DUKE POWER COMPANY

TECHNICAL REPORT

Ultrasonic Examination of Oconee Unit 3 Safe
End 3A1 and Unit 2 2A1 Piping

Attachment 2
Revised Information Regarding Question 1d, 2a, 4e, & 4f
in May 5, 1997
NRC Request for Additional Information

Station OCORCE Unit 3 Rev. _____ File No. _____ Sheet _____ Of _____
Subject RE-PLOT OF INDICATIONS WITH NEW THICKNESS OF .872"
REF. CAL SHTS. 9703001 FO & 9703020 By James W. Styles III Date 5-19-97
Prob No. 3A1-SAFE END PC-47 Checked By _____ Date _____

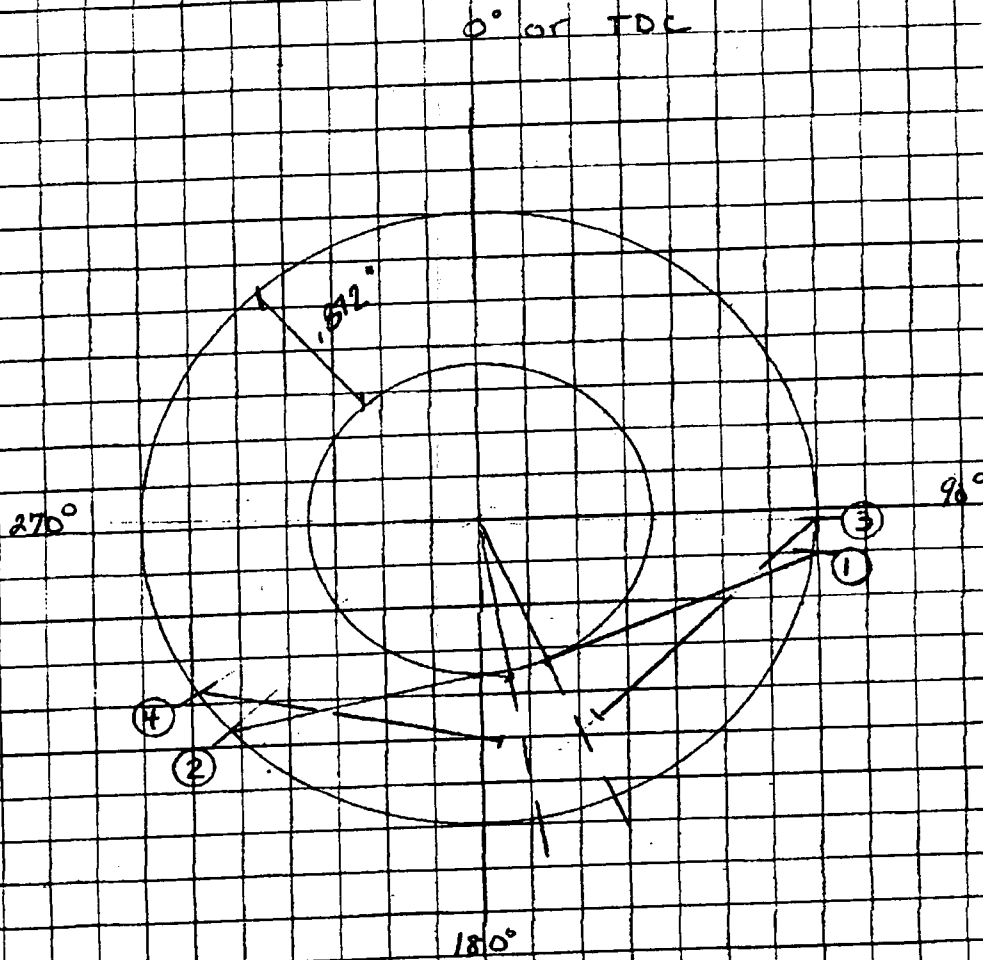
The results of the examination showed two suspected crack indications at 157° and 171° outside circumference azimuth location, (Figure 1). These indications were recorded as 0.5 in. long and between 2.25 in. and 3.05 in. from the edge of the safe end taper. They are located in the safe end base material adjacent to the nozzle-to-safe end weld parallel with the axis of the safe end. No other indications were recorded. The accuracy of the location of these indications is ± 0.1 in. along the safe end axis and ± 0.4 in. in the circumferential direction.

ONS-3 Safe End Crack Data

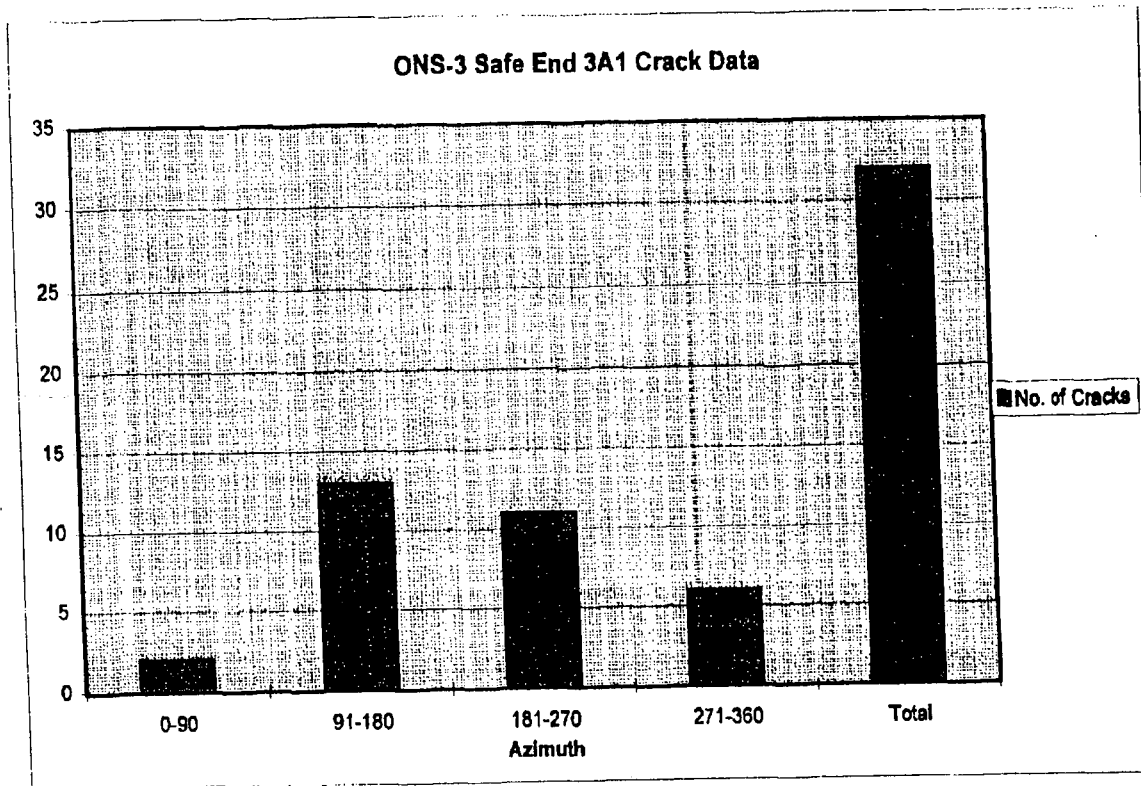
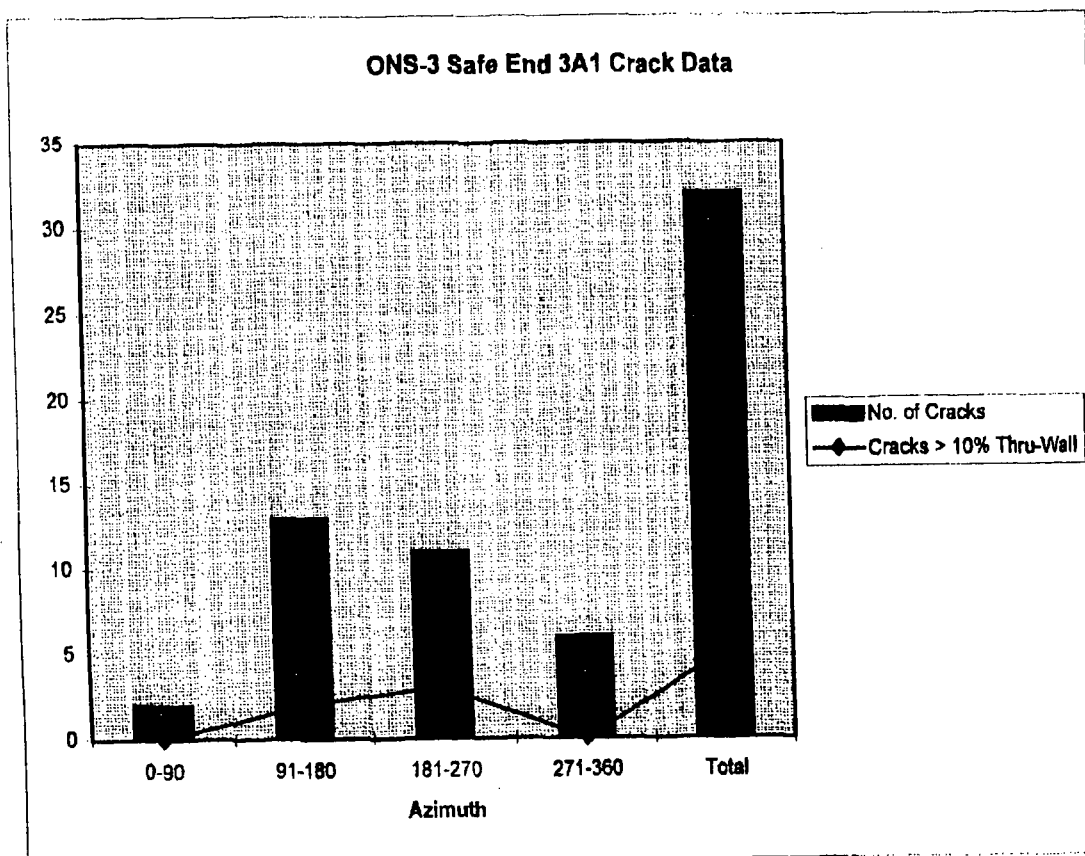
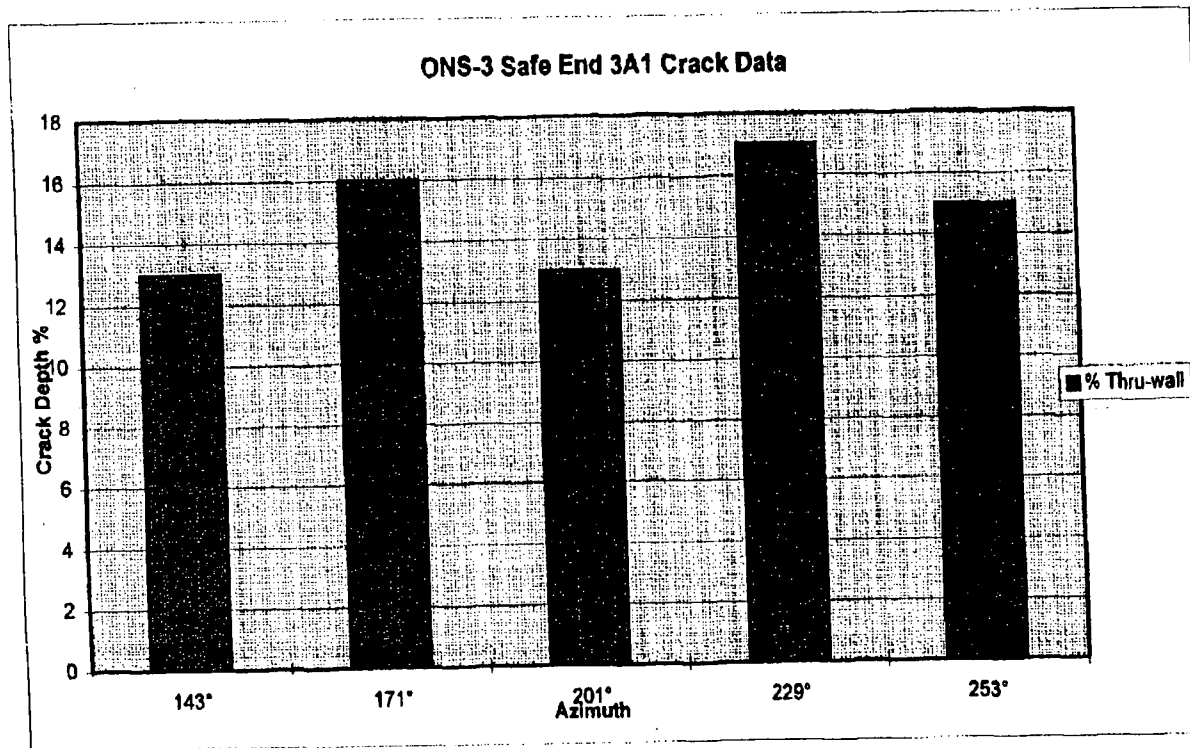
The safe end was sectioned at two locations in the cracked region. The first section was made approximately 0.5 inch from the field cut. Metallographic examination at this location shows thirty-two cracks around the inside circumference. There are five cracks greater than 10% through wall, and the deepest crack is 17% through wall (0.1474 in.). The cracks are more concentrated in the 91°-180° and 181°-270° azimuth locations than any other areas. The attached charts show more detailed information.

Comparison of the ultrasonic data with the metallographic results show that the indications recorded by the ultrasonic examiners correlate to known cracks at 143° and 171° on the Met Lab Report. These cracks are 13% (0.116") through wall for Indication number 1 and 16% (0.136") through wall for Indication number 2. Cracks less than 0.116" were not detected.

Twenty-seven other cracks with dimensions less than 10% through wall were not recorded. Three cracks with through wall dimensions greater than 10% were not recorded. They are located at 229° (17% tw), 253° (15% tw) and 201° (13% tw). All of the cracks are located at a change in section thickness on the safe end inside diameter. All three cracks were contained in a circumferential length of 0.8 in. on the inside surface. Factors, such as poor search unit contact, inside surface geometry and the skew angle of the cracks are being investigated as possible causes for not detecting these cracks. The most likely reason for not recording the three cracks at 229°, 253° and 201° is poor search unit contact.

Based on review of the ultrasonic and Met Lab Report, the ultrasonic procedure used to examine the safe end is capable of detecting cracks as small as 13% through wall. Poor search unit contact, inside surface geometry of the safe end at the crack location, and the skew angle of the cracks may have contributed to the inconsistent crack detection. These factors will be evaluated prior to the Oconee Unit 1 refueling outage and any improvements will be incorporated in the ultrasonic procedure.
